**HYDROGEOLOGY OF SPRING, CAVE, DRY LAKE, AND DELAMAR VALLEYS
IMPACTS OF DEVELOPING SOUTHERN NEVADA WATER AUTHORITY'S CLARK, LINCOLN, AND
WHITE PINE COUNTIES GROUNDWATER DEVELOPMENT PROJECT
REBUTTAL TO SOUTHERN NEVADA WATER AUTHORITY'S EVIDENCE REPORTS**

Presented to the Office of the Nevada State Engineer

on behalf of Protestants White Pine County, Great Basin Water Network, et al.

August, 2017

Figure 17: Portion of SNWA (2017b) Figure 2-12 showing the interbasin monitoring zone (in red dotted line), proposed monitoring, and water rights.

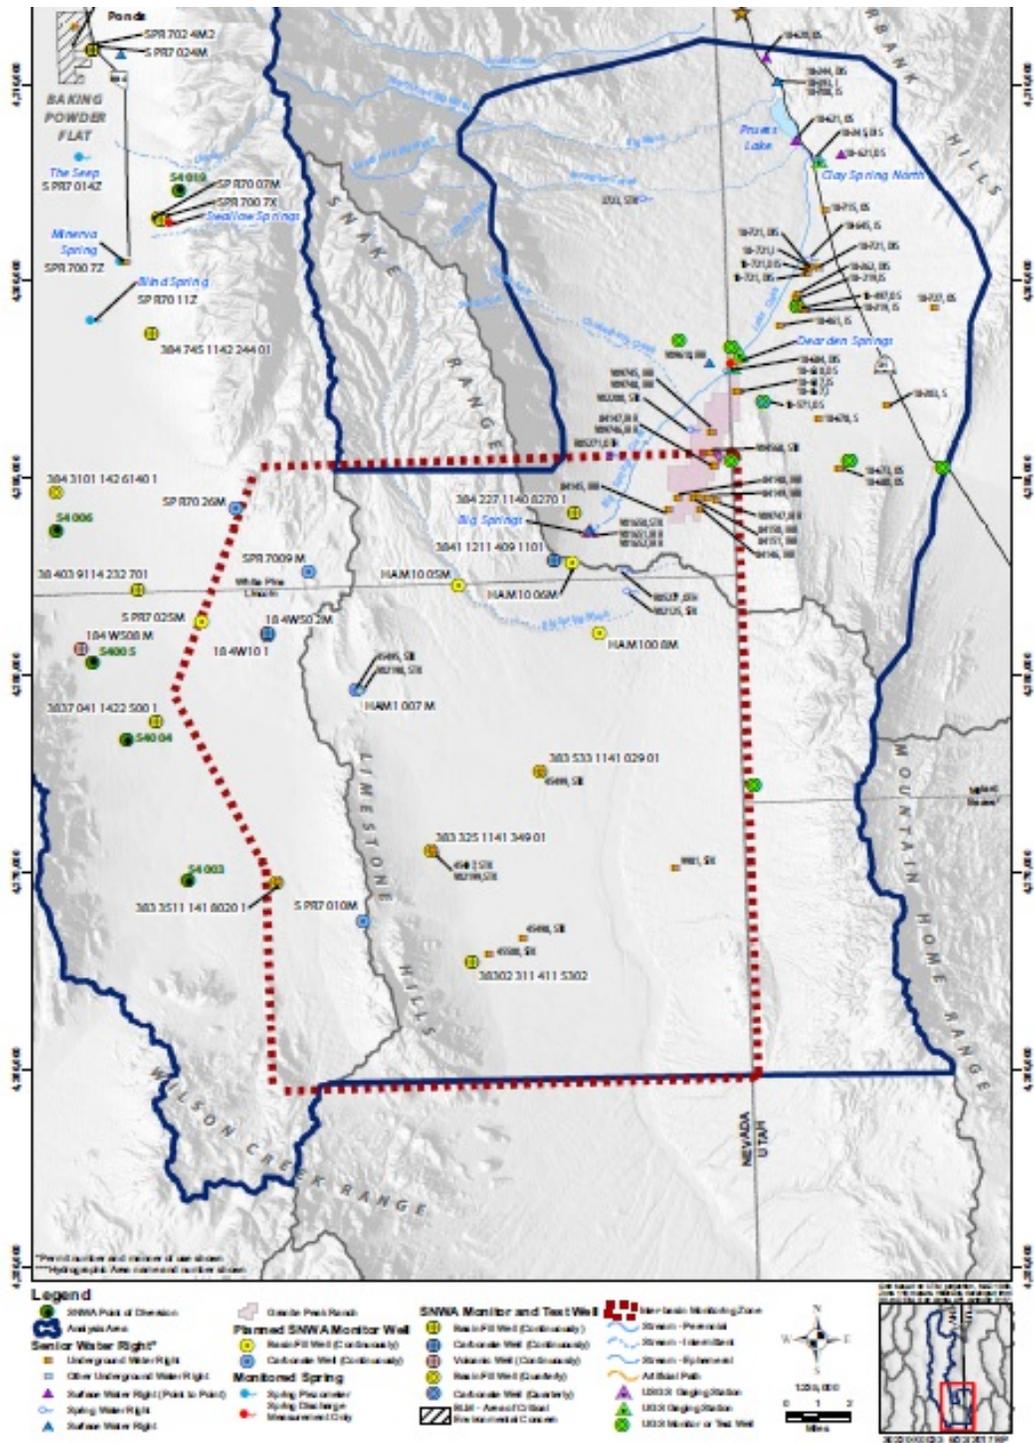
Figure 17 shows five monitor wells in carbonate rock along the boundary between basins, and about seven basin fill wells within Hamlin Valley (and one within Snake Valley). SNWA claims there will be two more wells sited after their final PODs are approved (SNWA 2017b, p 2-35), but provides no information regarding the siting or other specifics of those wells.

There is a ten-mile gap in the middle of the north-south transect along the Limestone Hills between SPR7010M and HAM1007M. Two proposed SNWA PODs lie west of this gap. The sentinel monitoring plan leaves a huge gap through which drawdown can expand into Hamlin Valley. Due to the heterogeneity of flow paths in carbonate aquifers, a much denser network would be required to have any confidence in the monitoring of expanded drawdown. The currently proposed network would only detect substantial drawdown in a given aquifer layer that is much more productive than other layers intersected by the well.

The basin fill monitor wells in Hamlin Valley are generally associated with specific senior water rights (Table 2-8 in SNWA 2017b, which also associates the general sentinel wells with senior water rights). As noted for the carbonate monitor wells, these wells screen broad sections of

basin fill which would mask the drawdown response within them. The basin fill well locations appear to have been established with no plan other than for them to coincide with existing rights. To that extent, the well locations would provide no warning time for mitigation, and thus mitigation would have no hope of being effective. Further, there is no apparent plan to monitor broader drawdown that would allow an understanding of how a decreased interbasin flow was affecting groundwater levels in Hamlin Valley.

- The carbonate well monitoring plan should have wells spaced on the basis of local-scale modeling showing the potential for drawdown to move through heterogeneous pathways through the hills.
- The carbonate wells should also have multiport screening or be constructed as nested wells to monitor the different productive layers.
- The basin fill well monitoring in Hamlin Valley should be redesigned to establish an accurate monitoring system of the groundwater table for the valley. This would require spacing of no less density than a monitor well per square mile, to allow for accurate interpolation of contours among the monitor wells.
- Shrubland habitat in the IBMZ should be monitored remotely, as done for the rest of Spring Valley. There should also be paired piezometers to estimate changes in vertical flux so that changes in the habitat can be modeled and predicted in advance.

Figure 18: Figure 3-5 from SNWA (2017b) showing a flow chart for management and mitigation actions for a senior spring or stream water right.

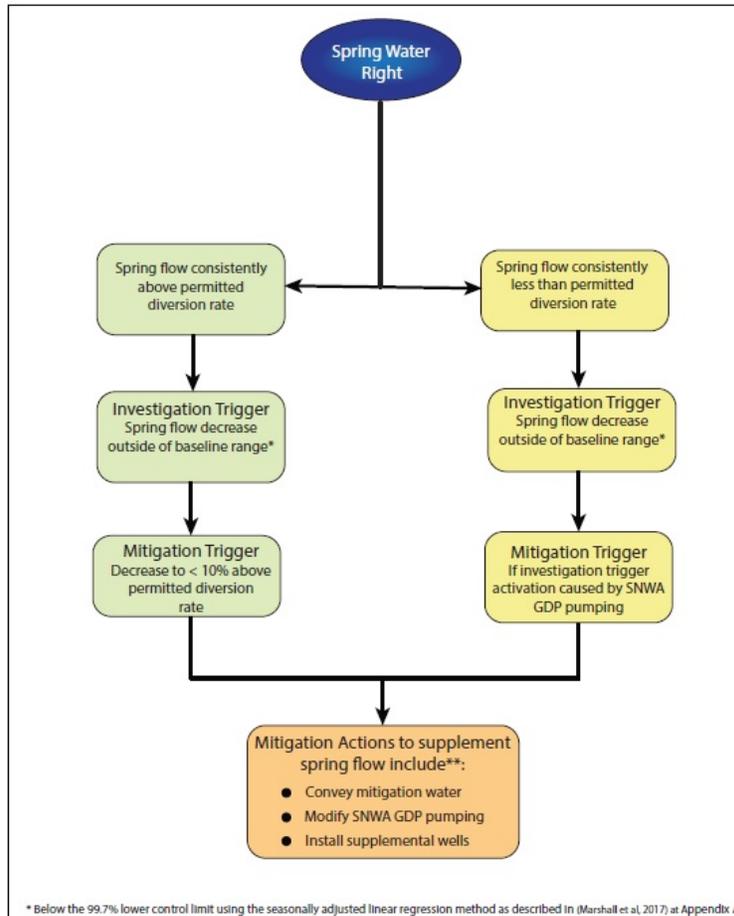
The proposal to mitigate springs with senior water rights is grossly insufficient and creates a situation in which SNWA can stall while they argue over who caused the springflow to decrease. If the spring flow has consistently been above the permitted diversion rate, then investigation would begin if the flow decreases to outside of the baseline range and mitigation would begin if the flow decreased to less than 10% above the permitted diversion rate. So, if the spring has a lot more water than is commonly used, the water right holder would be protected before the spring flow reaches the permitted diversion rate, but the environment, which would utilize the additional flow, would not be protected. If the spring flow is consistently less than the permitted diversion rate, investigation would begin once the flow decreases to less than the baseline range and mitigation would occur if the decreases causing the investigation trigger are determined to be "caused by SNWA GDP pumping" (Figure 18). This creates a likely conflict

over deciding fault. It also puts a larger onus on the water right holder if the permitted diversion rate exceeds the baseline spring flow because there is no conflict with the water rights holder who has the spring that flows at rates higher than his permit. Experience suggests that irrigators usually claim an amount that fully uses the source during a wet period and that most of the time, the flow is less than that permit amount. Spring water rights holders would have a more difficult time getting mitigation if their diversion rate frequently exceeds the flow rate.

Mitigation actions for senior spring or stream water rights would involve providing mitigation water, modifying production pumping, or installing a supplemental well (Figure 18). Mitigation water would be an amount equal to the beneficial use portion of the water right (SNWA 2017b, p 3-12). As Myers (2017) described, these actions would increase the environmental damages by further depleting the water source and because SNWA has applied for all unappropriated water within Spring Valley, would shift impacts to other areas, compounding impact problems.

Additionally, according to SNWA's proposed plan these actions would not have been determined to be reliable in advance if the water sources, the area from which mitigation water would be taken from, have not been identified. Modifying SNWA pumping would require a lag time before its effects would be felt. Drilling a well near the spring would likely draw water from the aquifer supporting the spring and simply increase the drawdown causing the spring to lose flow and guarantee the spring, and all its inherent values, would not ever recover.

Figure 19: SNWA (2017a) Figure 1-1 showing the area to be considered in the 3M plan for Cave, Dry Lake and Delamar Valleys.

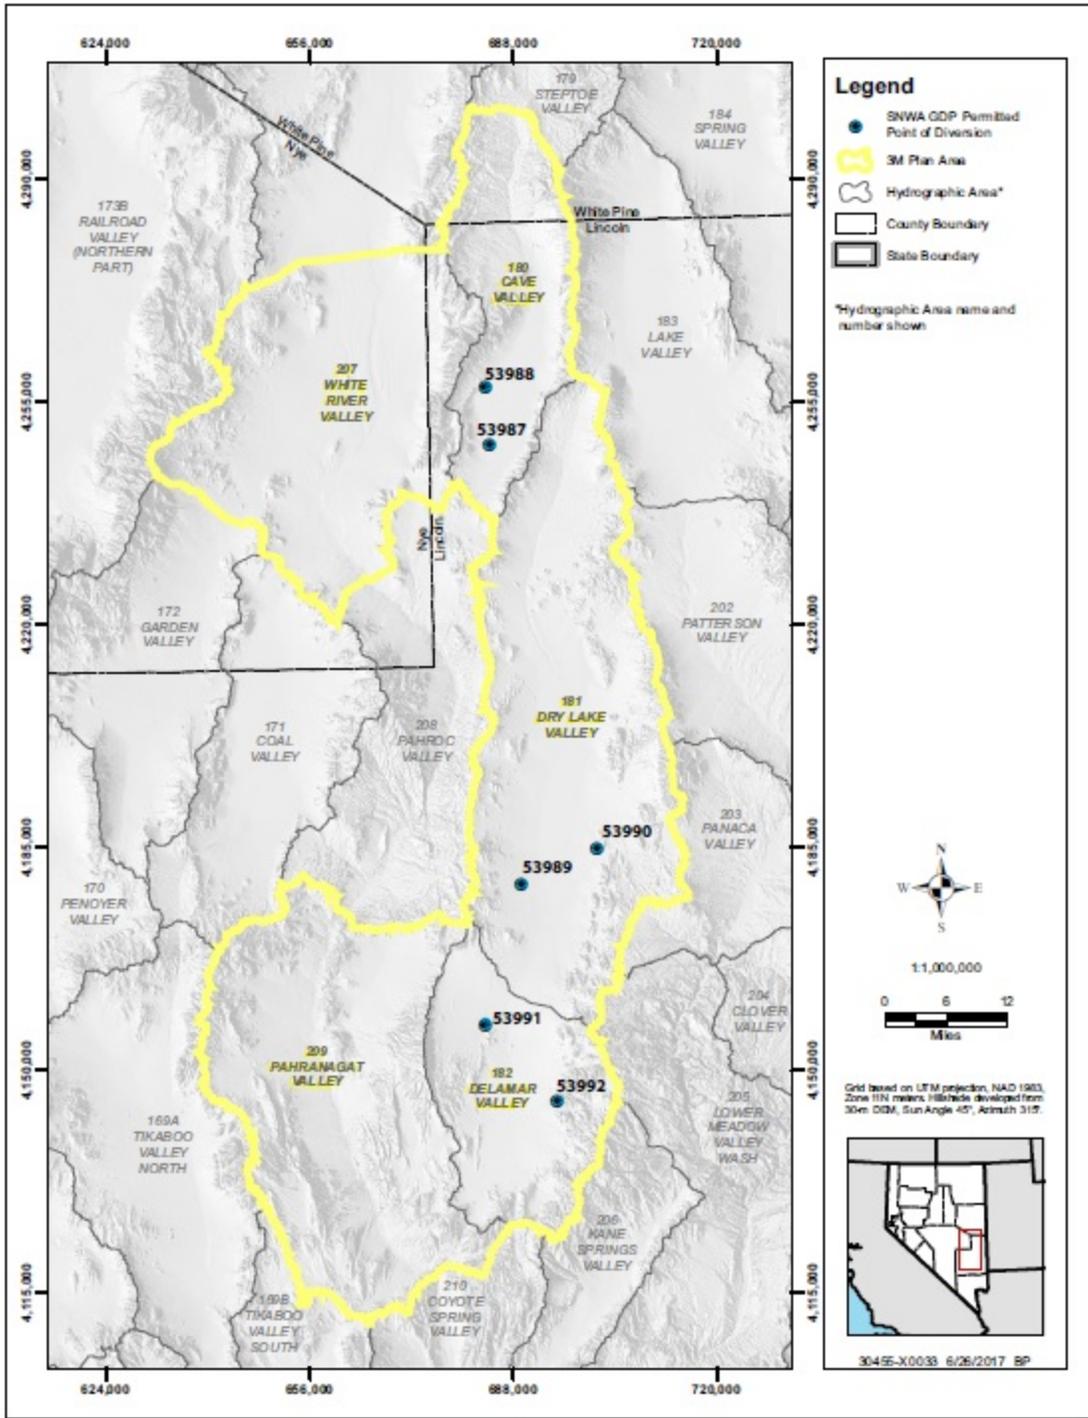
SNWA's DDC 3M plan (SNWA 2017a) focuses on the three targeted valleys, Pahranaagat Valley, and part of WRV rather than all downgradient water rights and springs in the WRFS (Figure 19). This scope is insufficient, as discussed above, because it ignores valuable springs and water rights south of Pahranaagat Valley, within the Muddy River Springs Area.

Figure 20: Portion of SNWA (2017a) Figure 2-4 showing springs, monitoring points, and points of diversion in White River Valley, Cave Valley, and Dry Lake Valley.

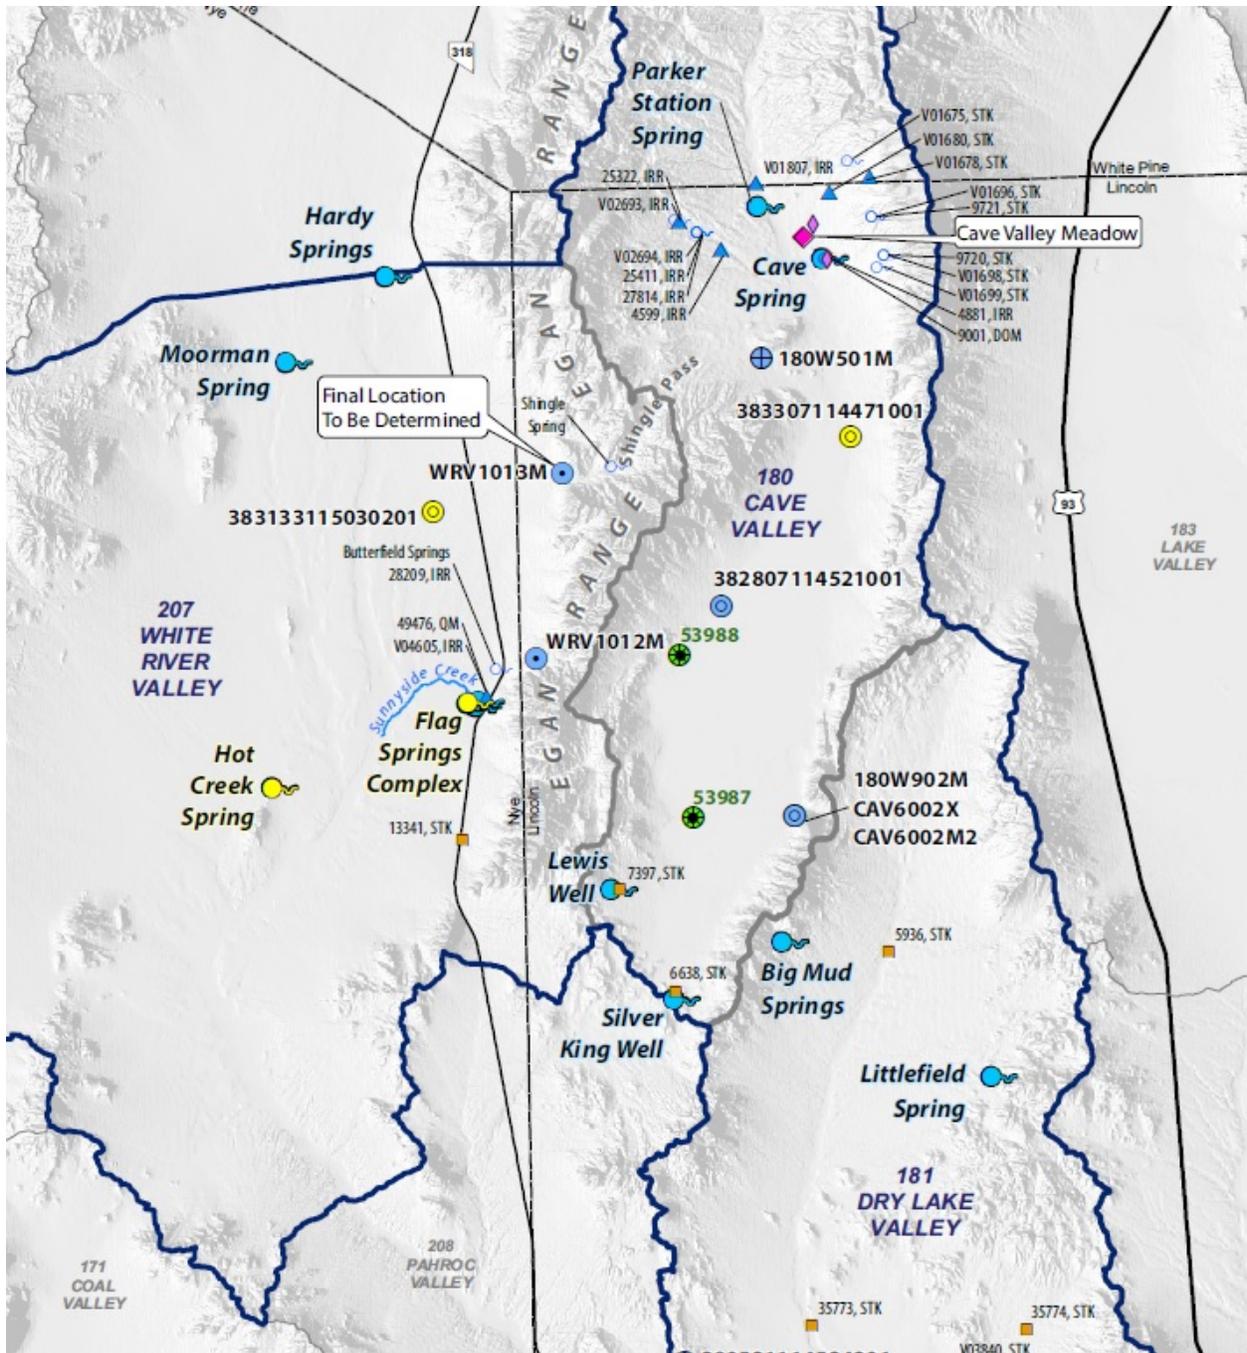
SNWA also claims it expects no effects in northern Cave Valley from the pumping in southern Cave Valley because the area is significantly higher (Marshall et al. 2017, p 8-7, -13). SNWA should consider the results of its groundwater modeling before making such a claim. FEIS Figure 3.2.2.33 (also Figure 25 in Myers 2017) showed that drawdown extends north of Shingle Pass in Cave Valley. Drawdown predictions also are not without uncertainty, and drawdown could occur beyond the predicted points. Uncertainty in predictions is part of the reason for monitoring. The CCFS model suggests that drawdown in Cave Valley draws flow from north to south and away from the pathway through Shingle Pass to White River Valley.

- There should be a transect of sentinel monitoring wells north of the production wells within Cave Valley to detect drawdown moving northward.
